February 24, 1994
Fort St. Vrain
ISFSI
P-94018

Docket No. 71-9253

SUBJECT: Response to the NRC's Request For Additional
Information Regarding the Model No. TN-FSV Packaging

**PSC RESPONSES TO NRC QUESTIONS ON THE
TN-FSV IRRADIATED FUEL SHIPPING PACKAGING**

Figure 1
FSV Operating History

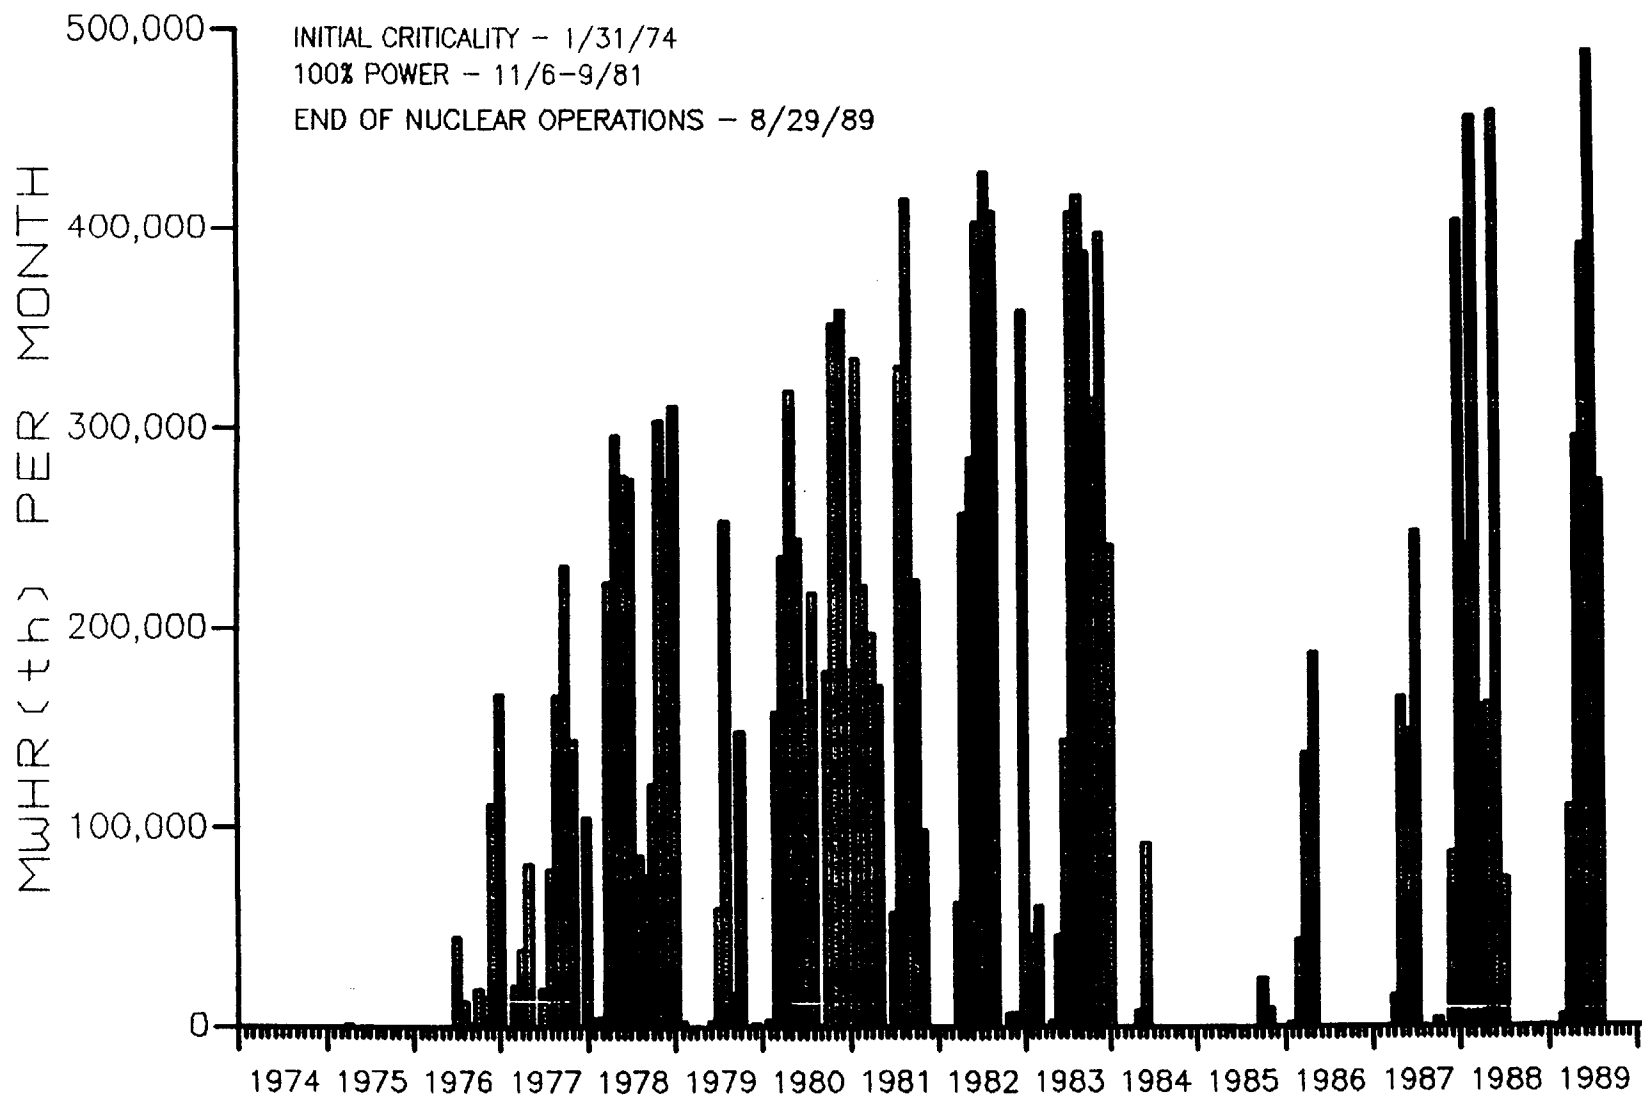
Specify the fuel parameters (e.g., isotopic composition, isotope masses, etc.) and fuel burn-up history (e.g. reactor power, number of cycles, up-time and down-time per cycle, etc.) that were used to determine the shielding source terms. Show that these parameters and burn-up history adequately represent the FSV fuel and provide the bounding source terms.

The operating history of the FSV plant was quite sporadic throughout its life. Therefore, modelling the actual power history was extremely difficult. Figure 1 summarizes the Fort St. Vrain operating history.

Figures 2.10.1-15, 2.10.1-15a, 2.10.1-16, 2.10.1-16a, 2.10.1-17 and 2.10.1-17a graphically depict these loadings.

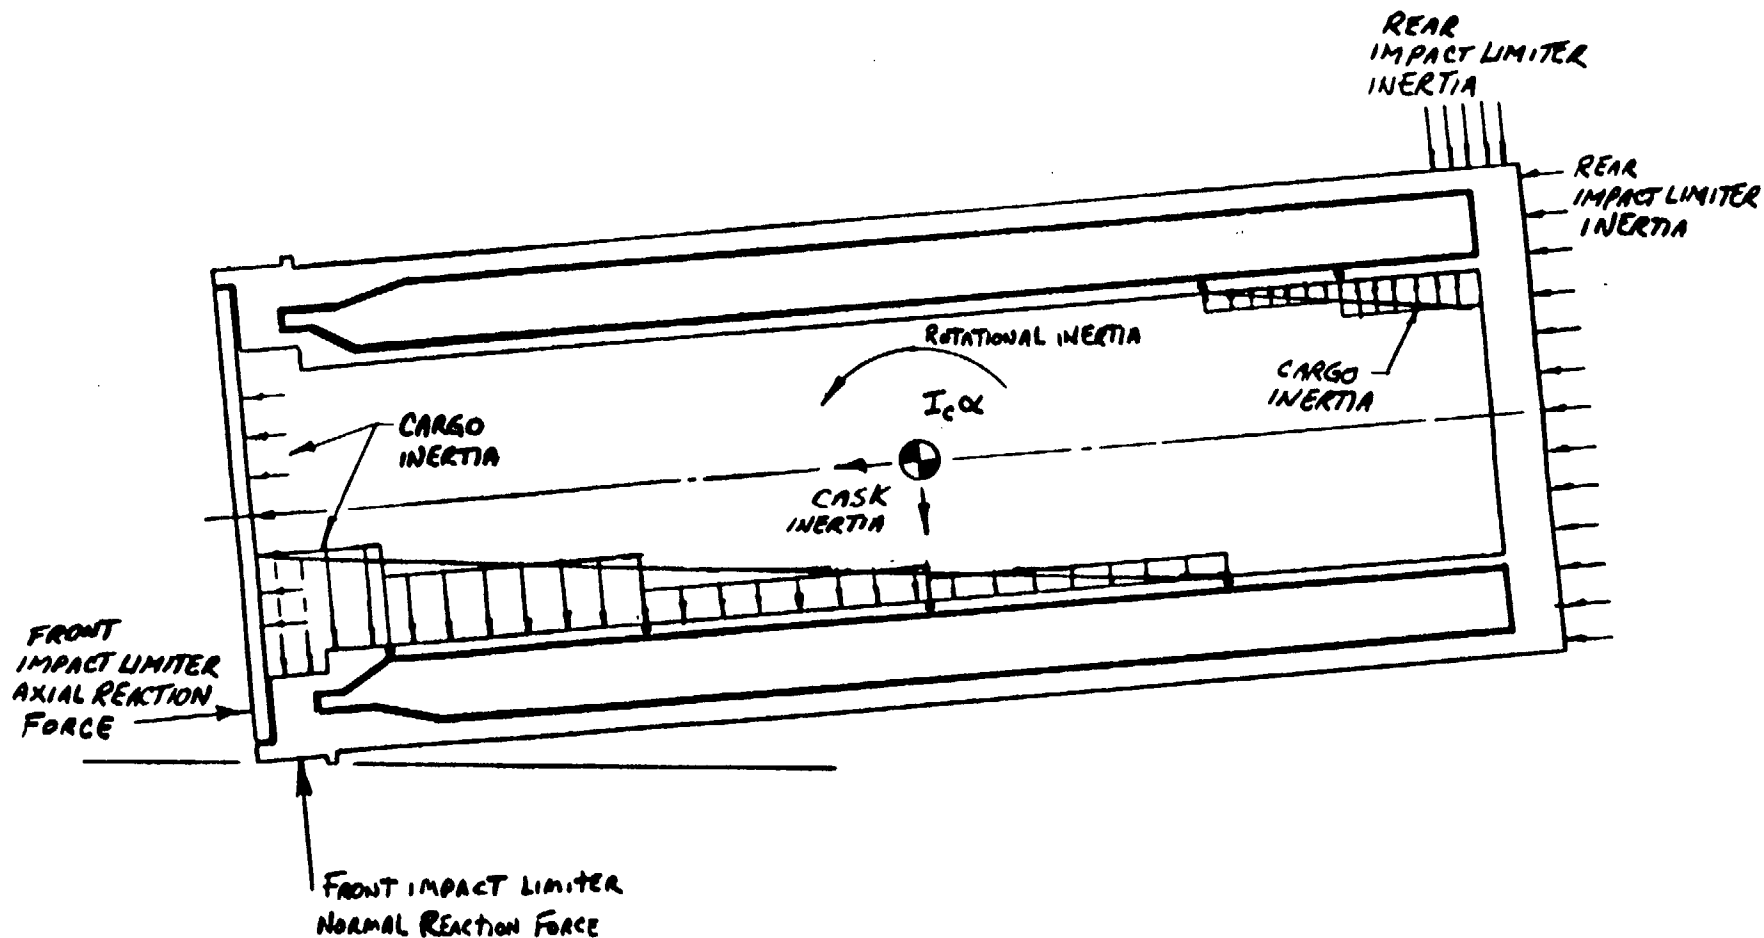
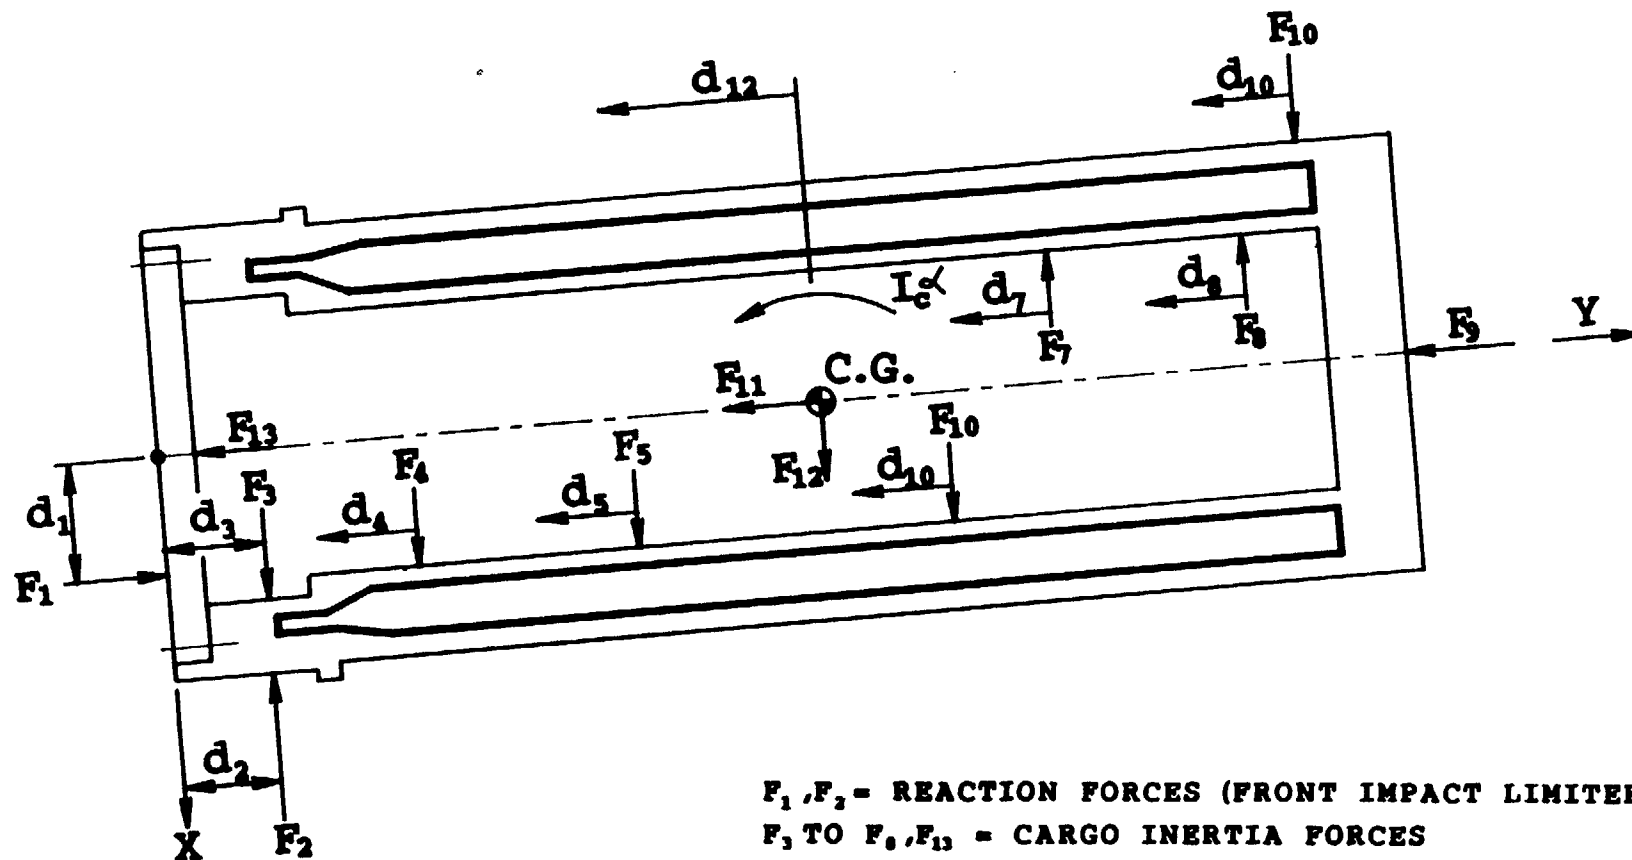
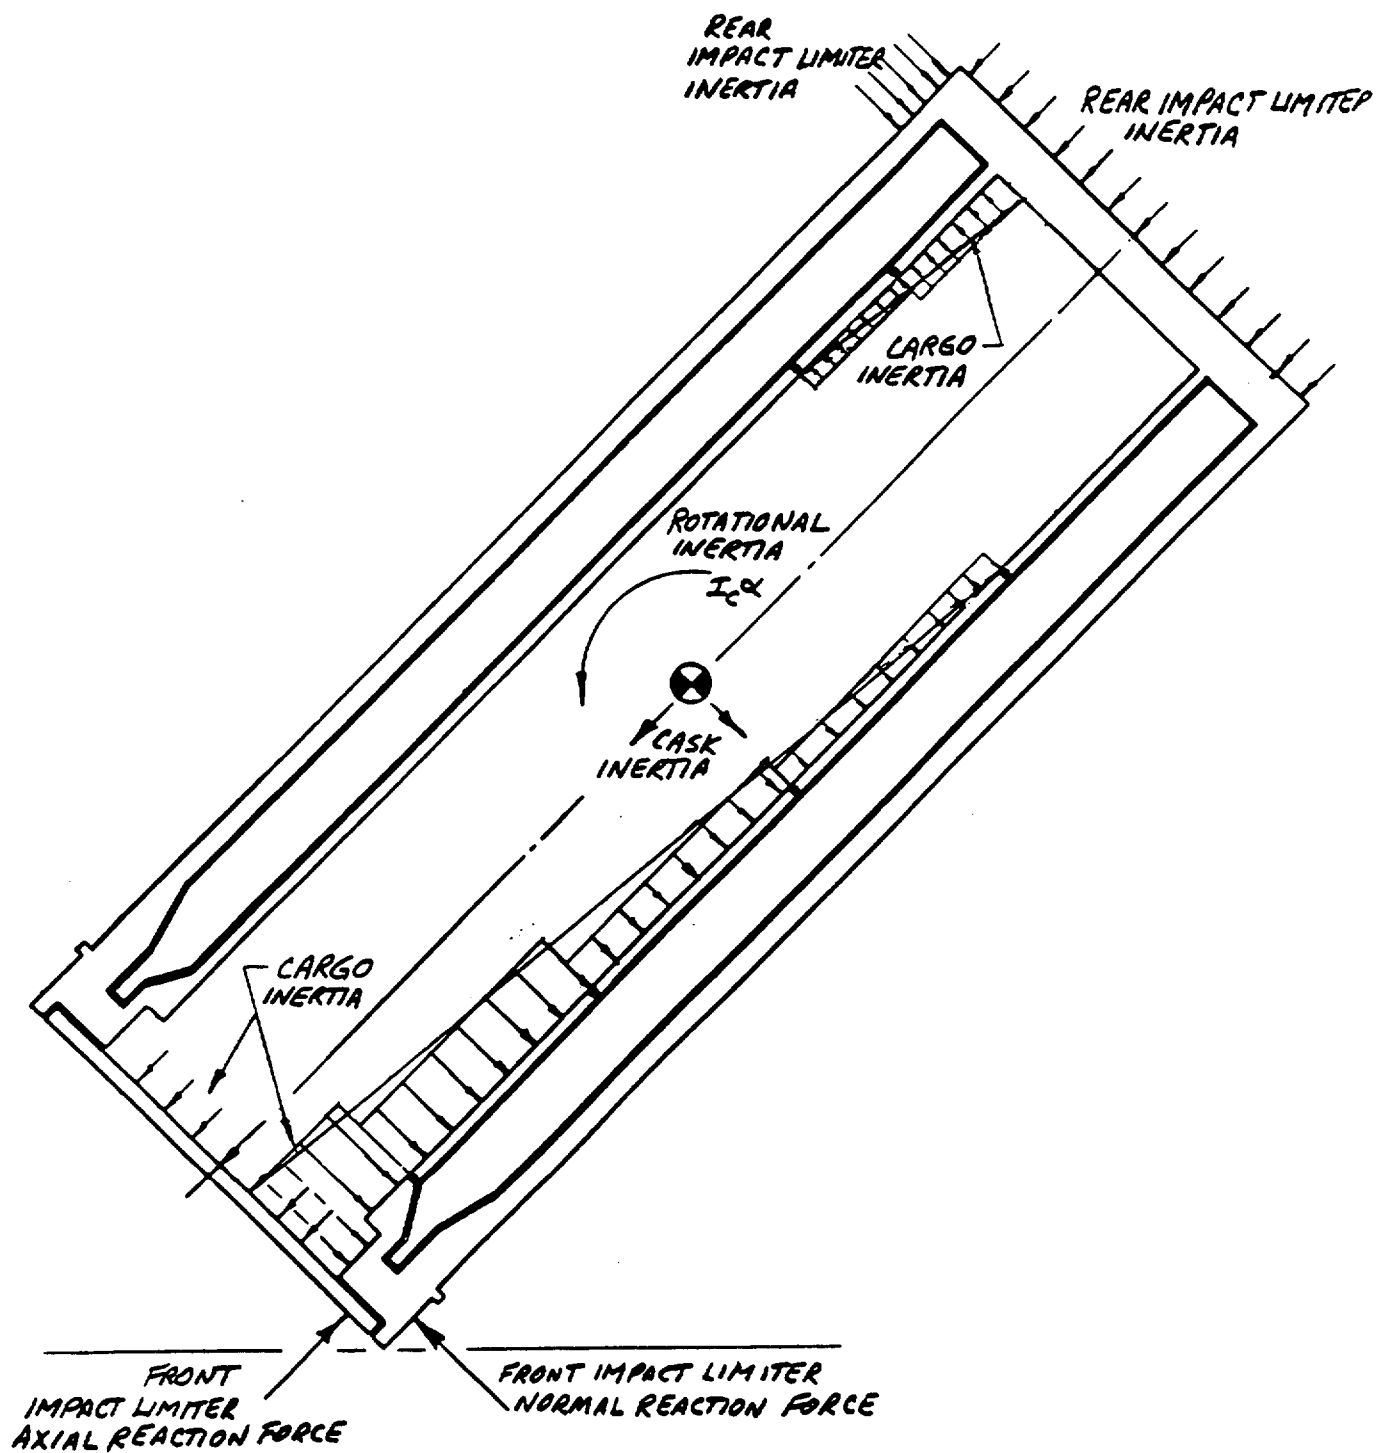
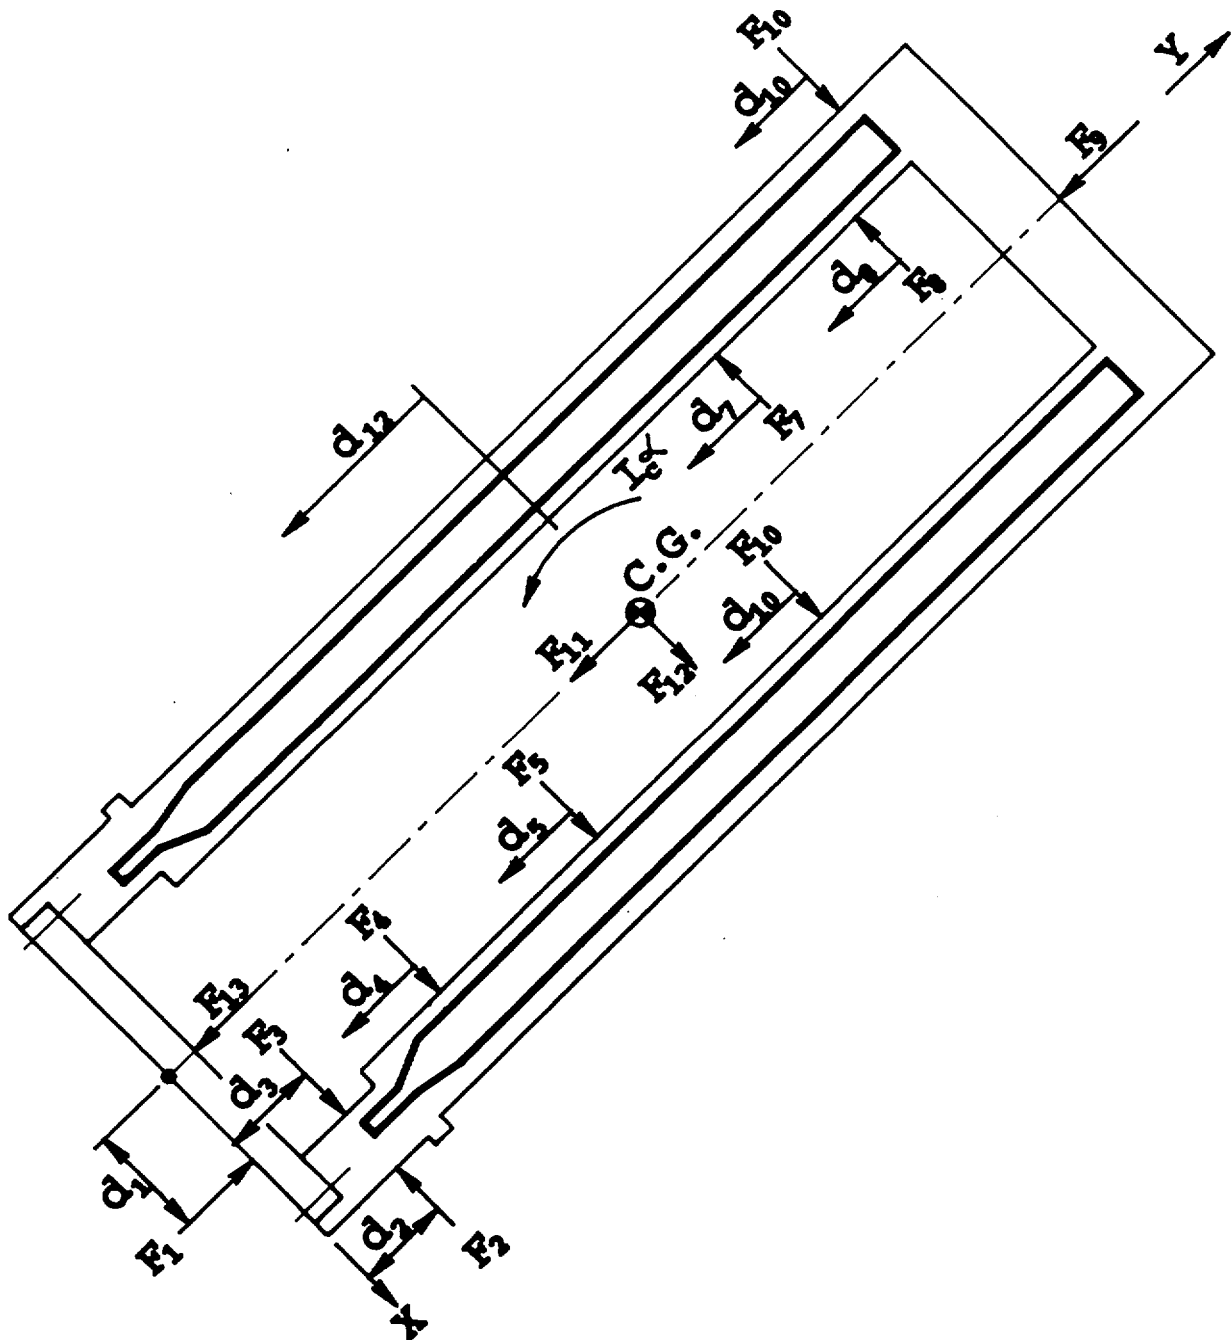
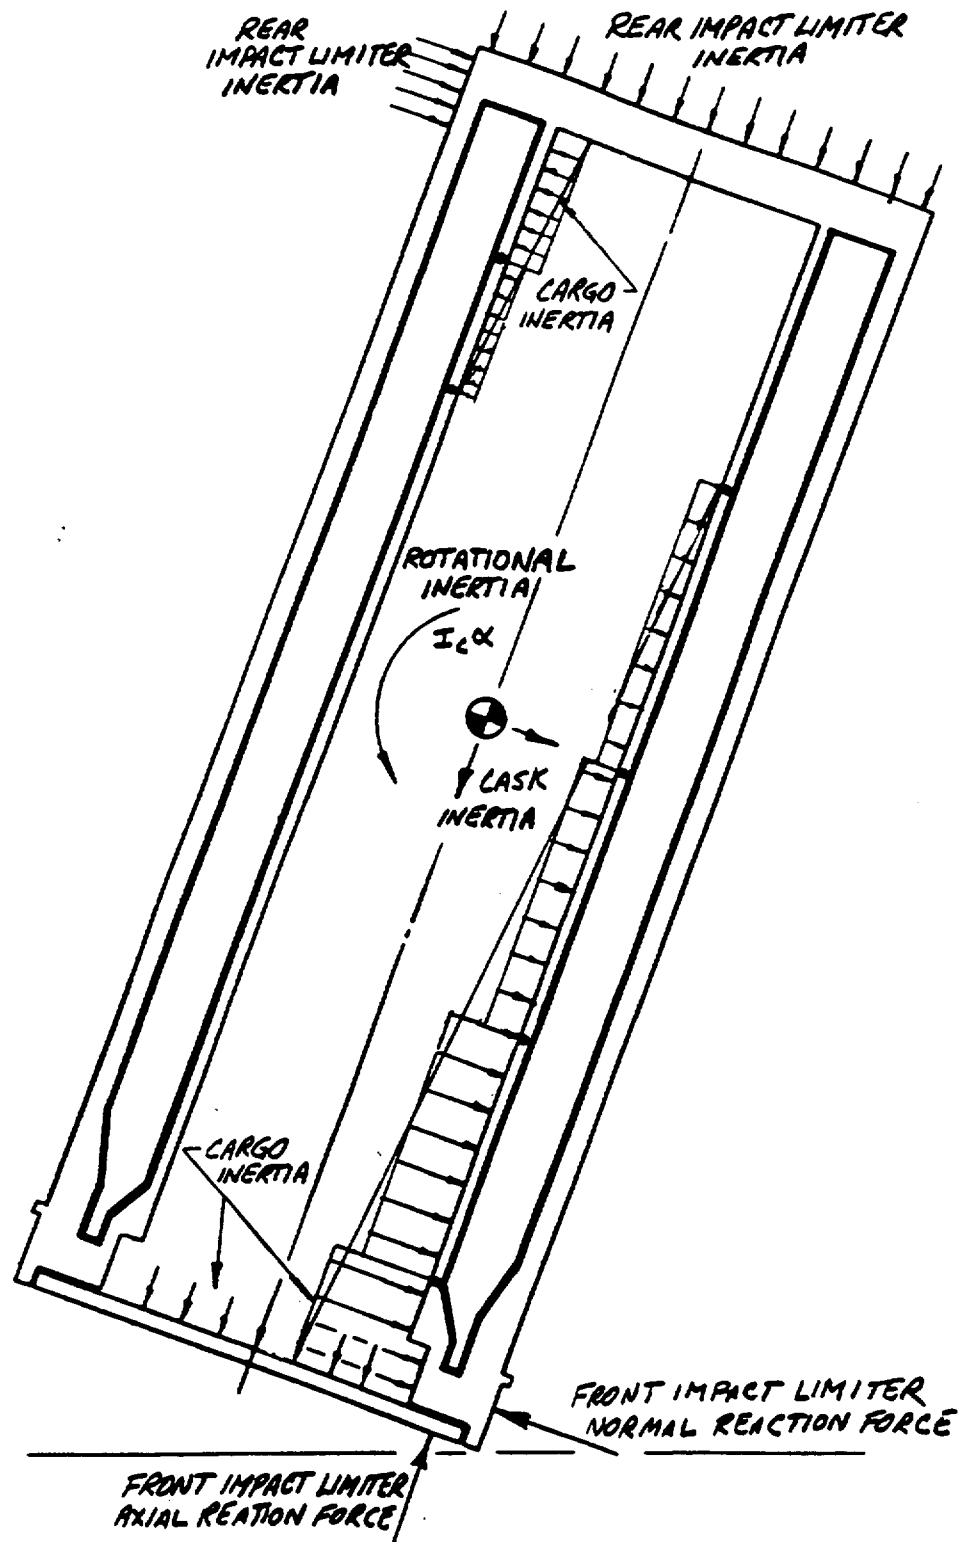
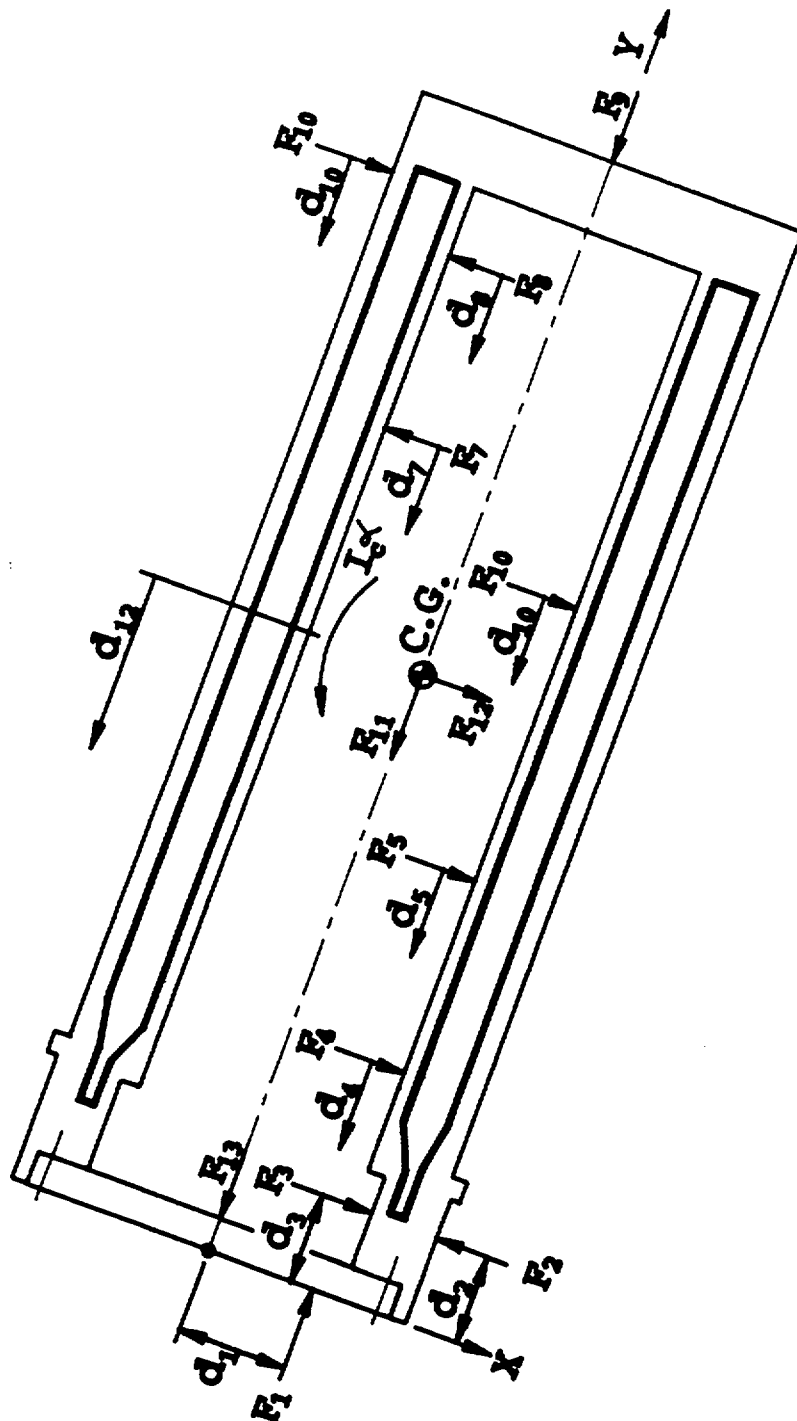
Revise the application to show that the inertia g values and forces used in ADOC computer code for the structural analyses are conservative, considering results of the impact limiter testing.

As discussed in Appendix 2.10.3, the dynamic tests results correlate reasonably well with the results from the static crush tests which confirm that the forces used in the stress analysis for the cask are conservative.
